PCB layout

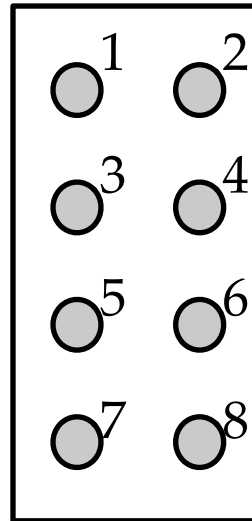
C3 removed

C6 removed

50 ohm

Replacement part

PSCQ-2-120

Pins 3, 4, 8 (all GND)
not connected

R4 = 50 ohms still in place
